Cumberland County Subdivision and Land Development Review Report

Municipality:	<u>Upper Mifflin</u>	Surveyor/ Engineer:	<u>Byers & Runyon Surveying</u>	Owner/ Developer:	<u>Martin L Weller</u>
Plat Title:	<u>Martin L Weller</u>				
Plat Status:	<u>Preliminary/Final</u>	Plat Type:	<u>Subdivision</u>		
# of New Lots:	<u>1</u>	# of New Dwelling Units:	<u> </u>	New Acreage Subdivided/Developed:	<u>2.12</u>
				Total Tract Acreage:	<u>8.14</u>
Zoning District:	<u>N/A</u>	Proposed Land Use:	<u>Residential/Agricultural</u>		
Date Received:	<u>8/21/2020</u>	County Review:	<u>8/31/2020</u>	Reviewed by:	<u>SH</u>
				Checked by:	<u> </u>

LAND SUBDIVISION

MARTIN L. WELLER

Sheet 2 of 2

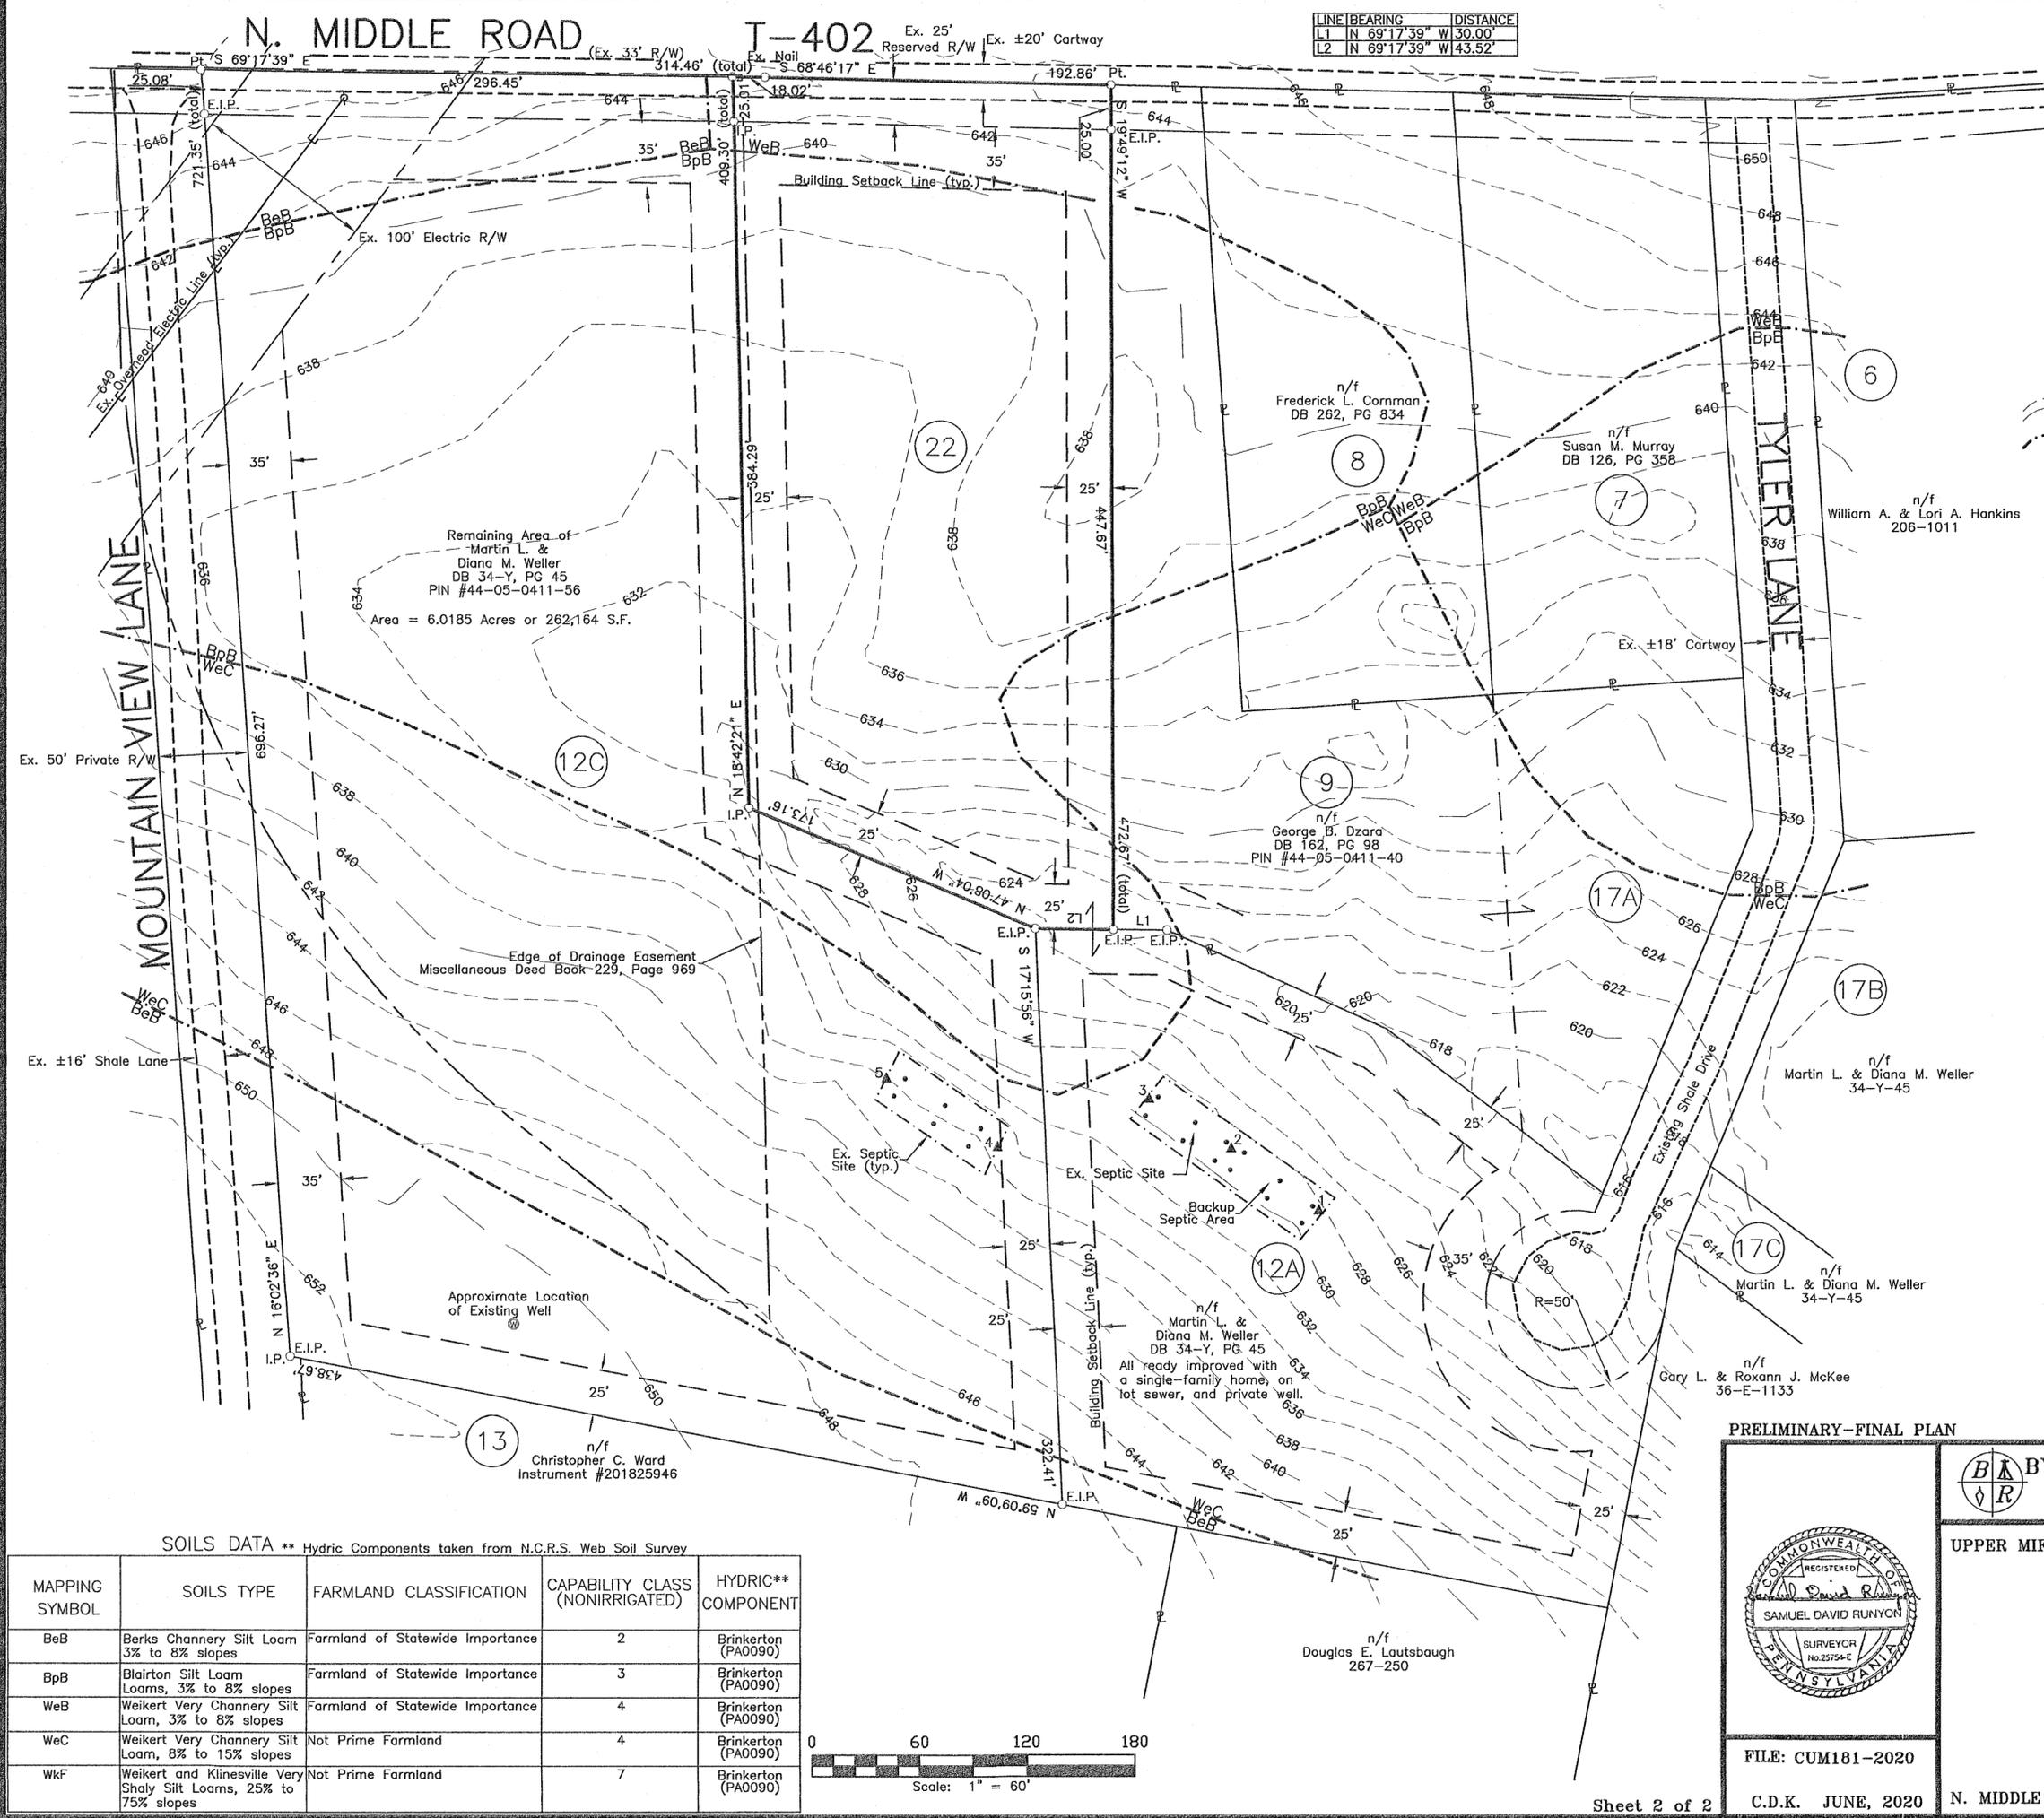
2. The purpose of the plan should be clarified. The current purpose of the plan as noted on Sheet 1 is to subdivide lot 22. The lots shown on Sheet 1 should be the same as Sheet 2 with the exception of the proposed subdivision to lot 22. It appears that subdivisions that were already approved or pending are not updated on the Sheet 1. The plan should include notes clarifying these discrepancies.

- a. The plan indicates that lots 10 and 12 will be consolidated into lot 12C.
 - b. Lots 10A and 12B shown on the Sheet 1 are not shown on the Sheet 2.

- c. The "Lot 22" block on Sheet 2 should include lot 22. Currently, this section of the plan indicates that lot 12C will be a lot addition to previously approved Lot 12A.

3. The Notes block should include proposed dimensional figures to verify compliance with the regulations noted.
4. When obtaining the county signature for the final plan recording process, the applicant / engineer should provide a CD that includes a .dwg AutoCAD file that shows all of the parcel boundaries, lot lines, building footprints, road rights-of-way and the edge of pavement. For more information, please visit the Cumberland County Planning Department website at: <https://www.ccpa.net/3185/Plan-Submission-Recording-Procedures>.
